Access Compliance Report Public Rights-of-Way (Curb Ramps)

Main Street: ROOSEVELT_AVE Cross Street: NEWLAND_ST Location: NW

ADA ID: RPRK211001134339 Ramp Type: Type 1 - Perpendicular Diagonal Initial Pass/Fail: Fail Overall Compliance: No Severity Score: 19

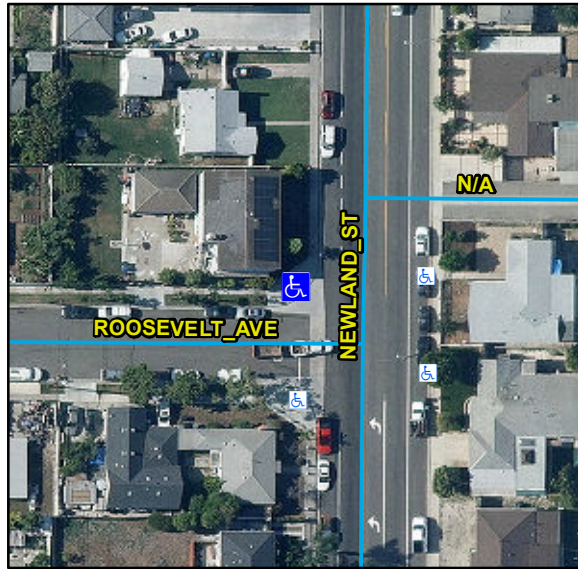
R304.2.2, R304.5.1, STD 1115

Remove & Replace Curb Ramp With Two New Directional Ramps or Equivalent.
